Major-Domo
May 2001 — 000184-1

AM Receiver
February 2001 — 000176-1

Darkroom Timer
April 2001 — 000182-1

PPP Valve Power Amplifier
May 2001 — 000118

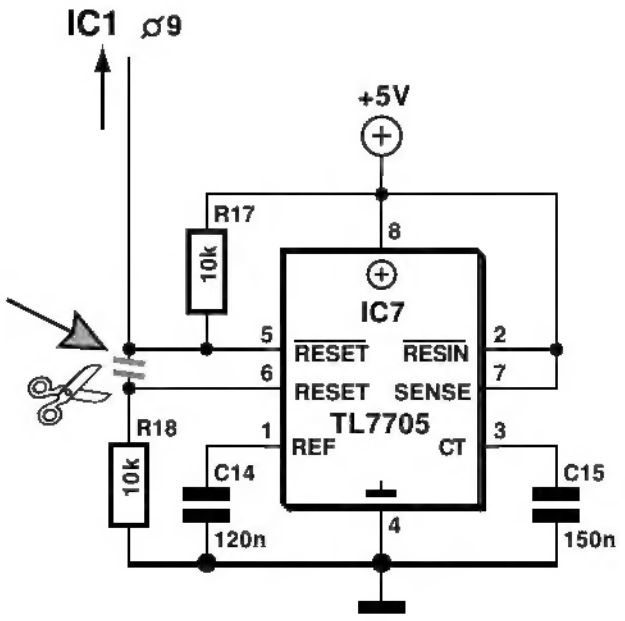
Pins 5 and 6 of IC7 have been mixed up in the circuit diagram and on the PCB. Pin 6 should go to R18 only. Pin 5 is connected to pin 9 (RESET\) of IC1. The modification to the PCB is illustrated here.
